Commonwealth Edison
One First National Plaza, Chicago, Illinois
Address Reply Post Office Box 767
Chicago, Illinois 60690

Subject: Dresden Station Units 2 and 3
Quad Cities Station Units 1 and 2
Containment Vent and Purge
Valve Operability
NRC Docket Nos. 50-237/249 and
254/265

ATTACHMENT 1

Response to Request for Additional Information
Quad Cities 1 & 2 and Dresden 2 & 3
Containment Purge/Vent Valves

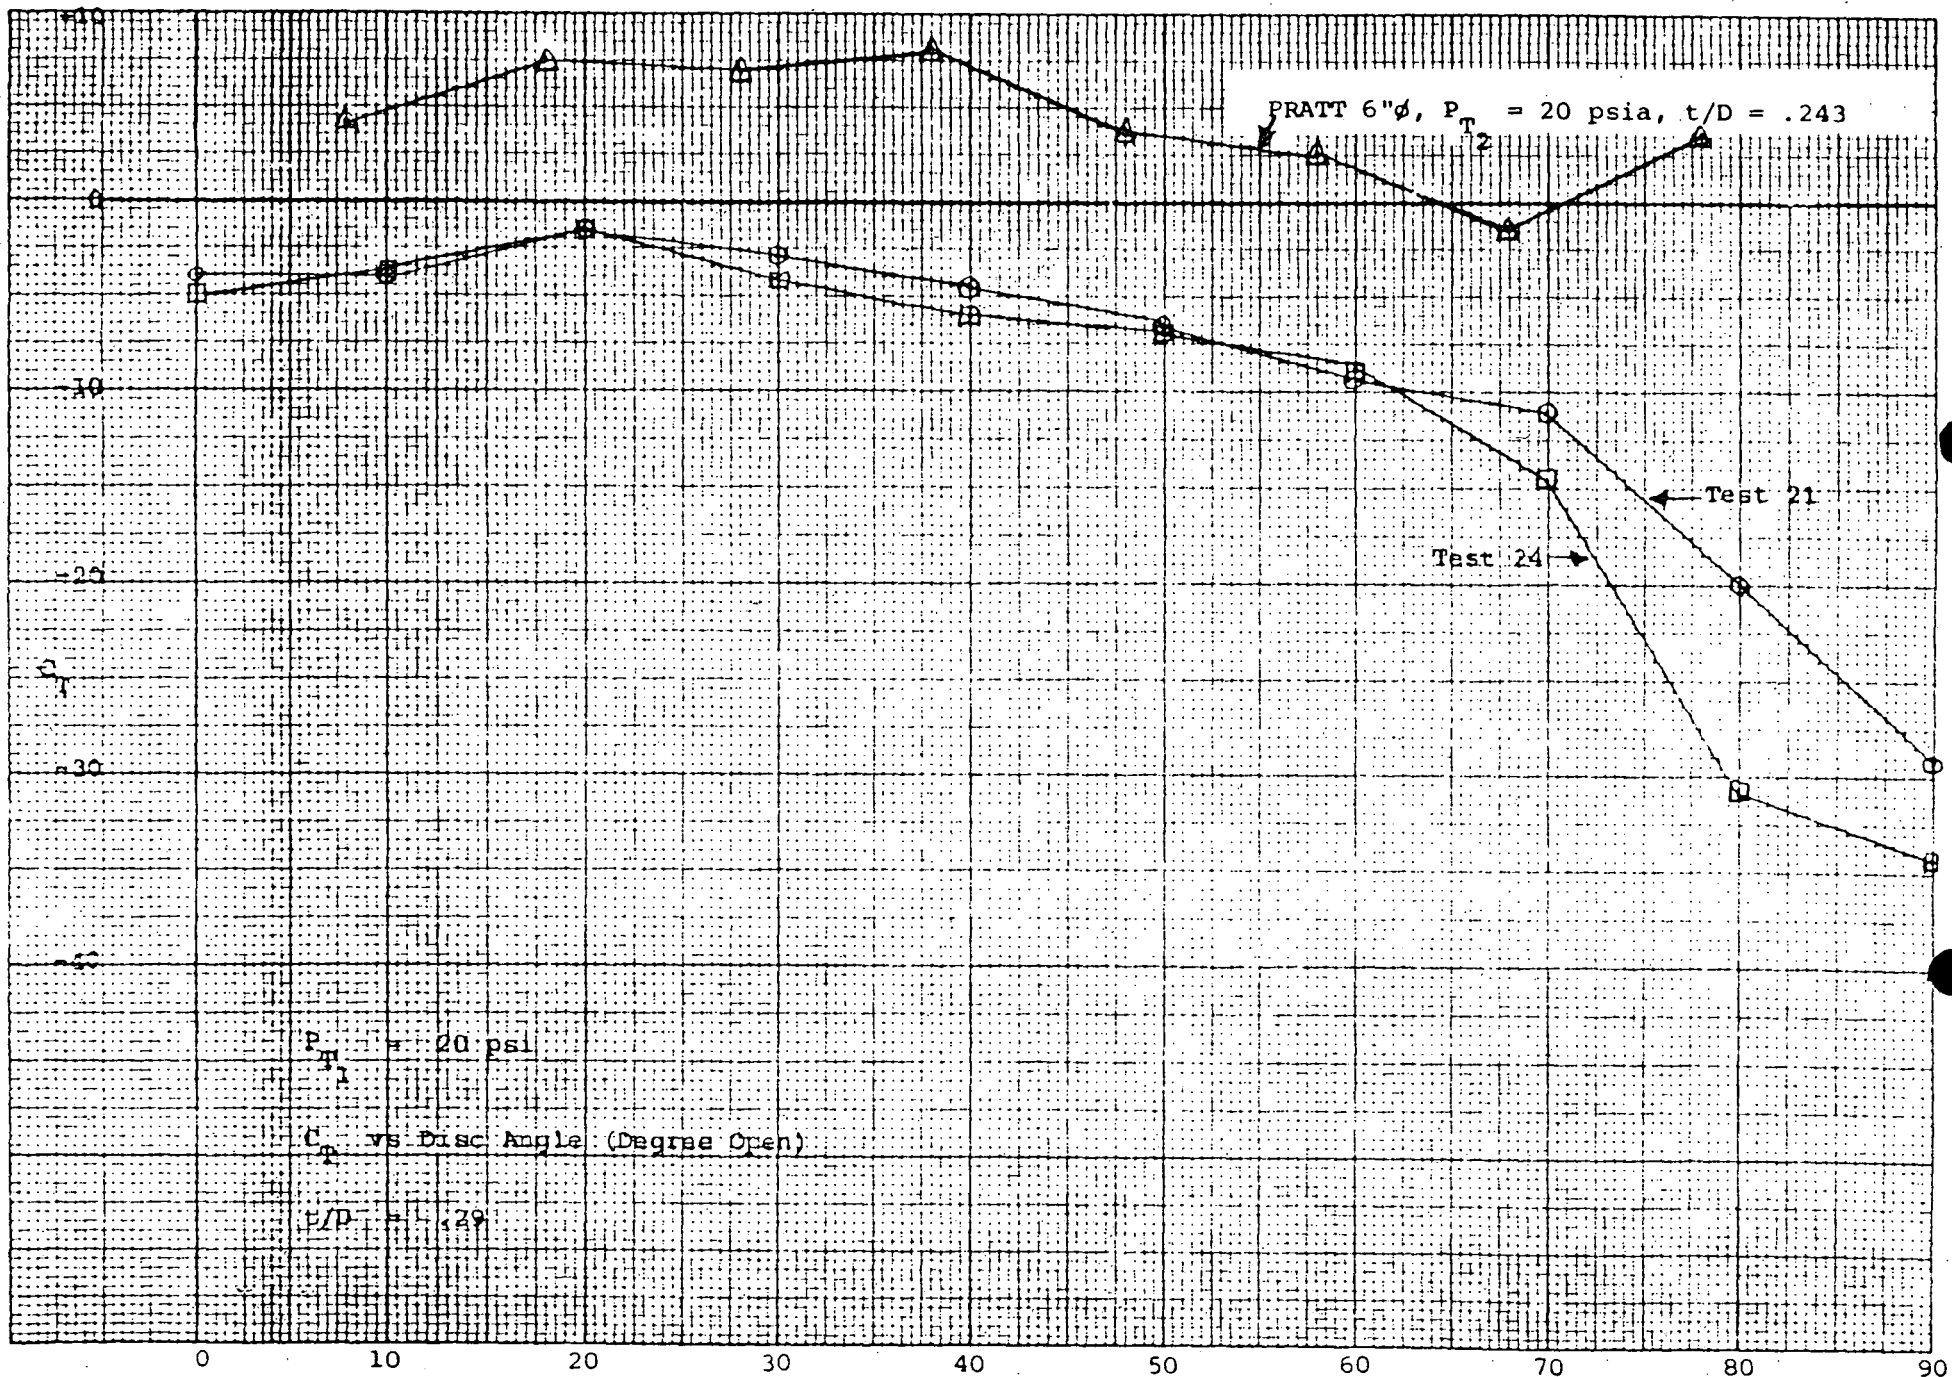
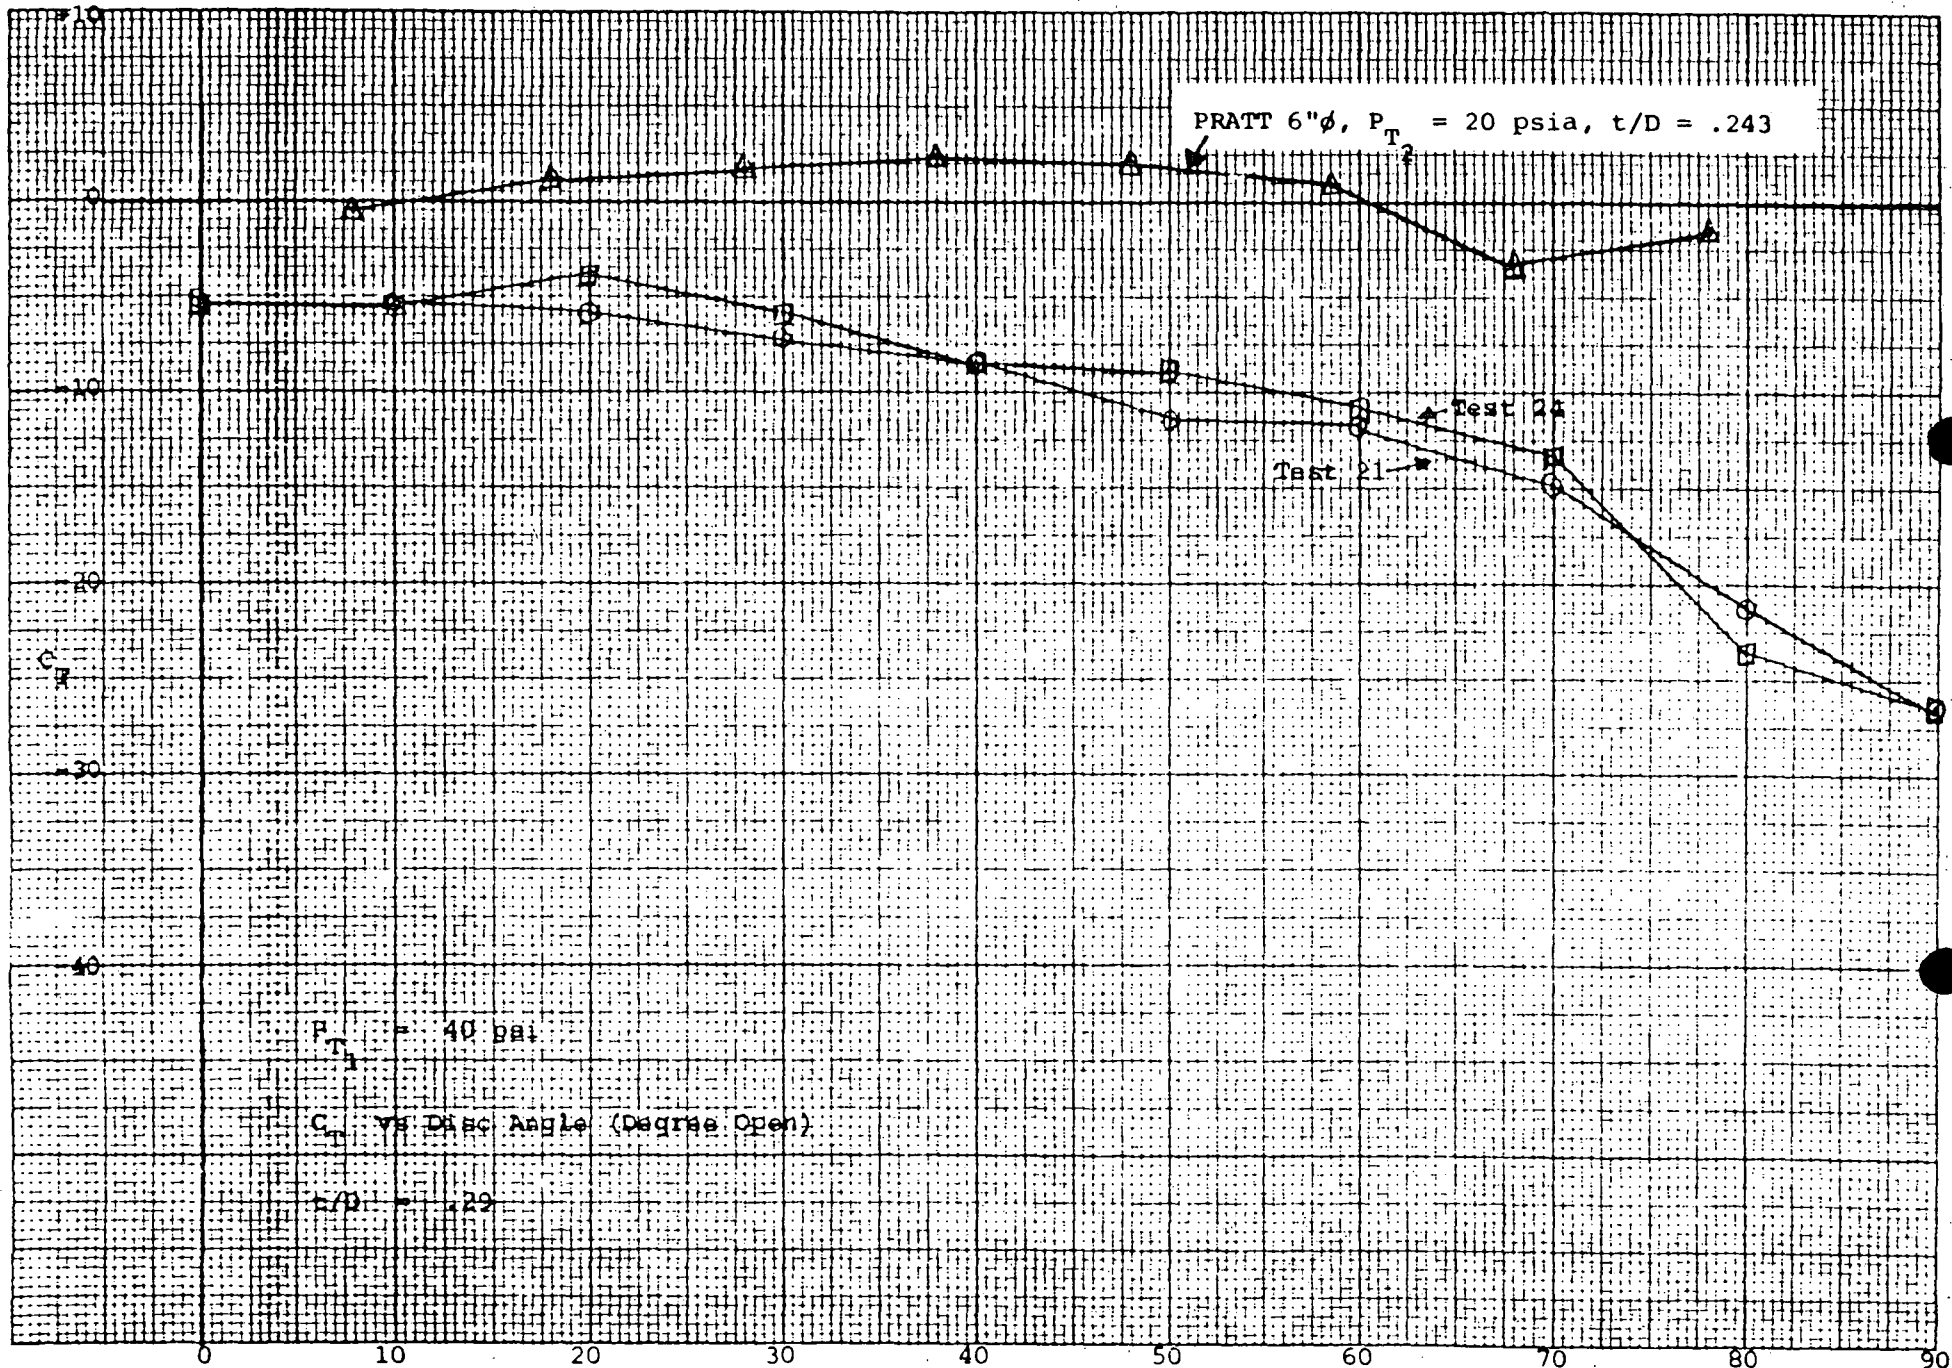
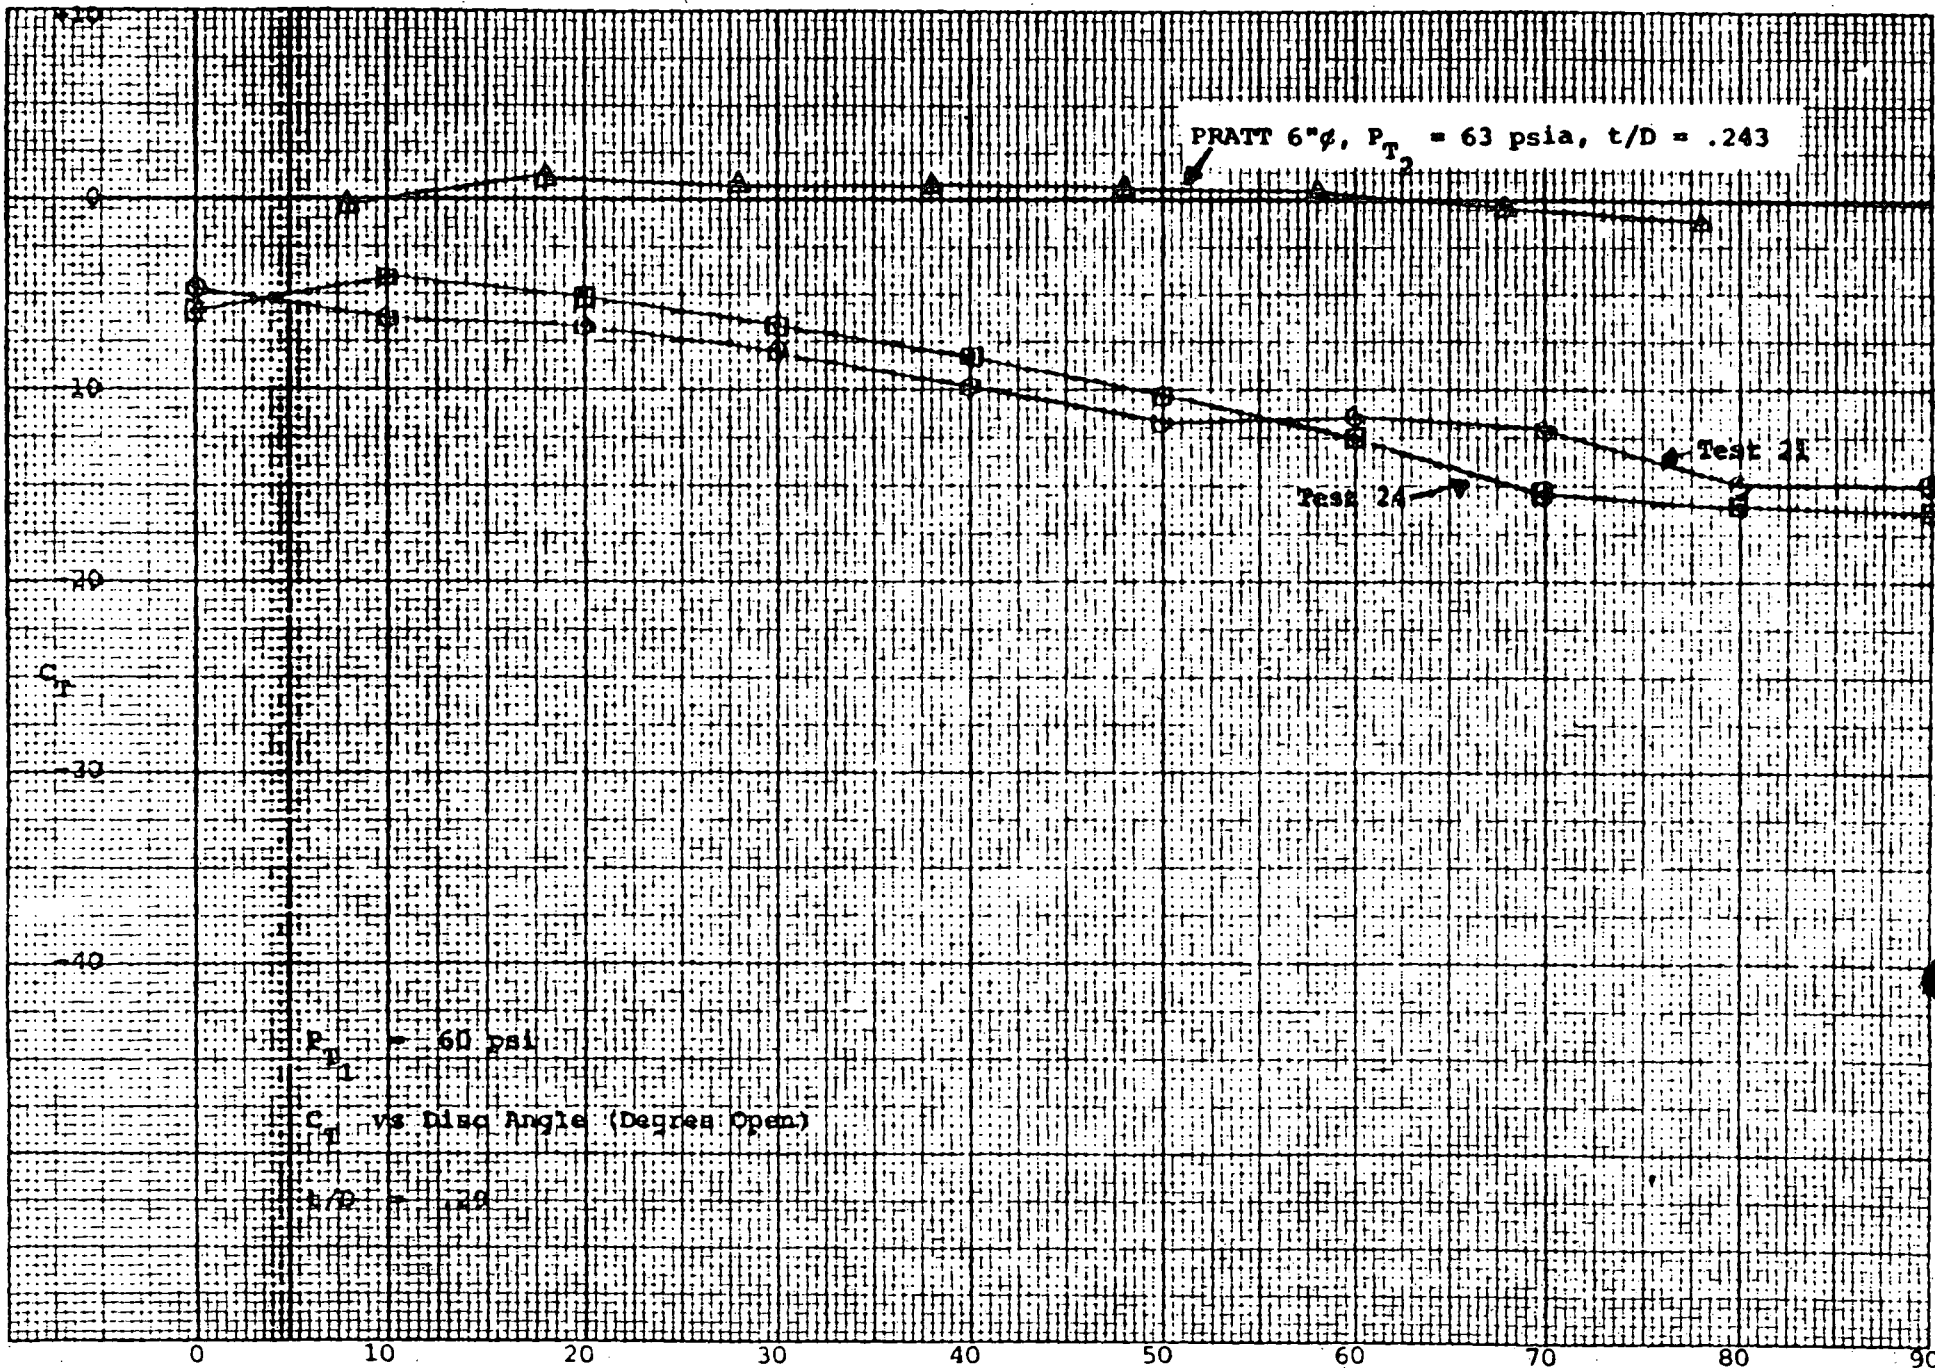
Question 1.1: Describe how each of the valve installations, relative to the piping configurations, have been reviewed to assure that the dynamic torque coefficients (C_T) developed by Fluid dynamic testing are applicable to the Dresden & Quad Cities valves. C_T can be affected by shaft orientation relative to close proximity of upstream elbows and disc closure direction relative to these close proximity upstream elbows.

The C_T information for Pratt valves in Tables II.1, II.2, and II.3 and tables extracted from the Allis-Chalmers report have been summarized in Figures II.1, II.2 and II.3. These figures show that the shape of the "in-plane" C_T curves are similar and that the maximum difference between C_T "in-plane" and C_T "out-of-plane" for sonic conditions ($P_{T1} = 40$ or 60 psia) for Allis-Chalmers STREAMSEAL valves is a factor of 1.283.

The maximum torque on a Pratt eighteen (18) inch butterfly valve, as scaled from test data gathered at Fluidyne, is 216 ft-lbs. Multiplying 216 ft-lbs times 1.283 yields a maximum torque value of 277 ft-lbs for "out-of-plane" valves. Since this is less than the 300 ft-lbs used in the valve analysis (Reference 1), no further evaluation is necessary.
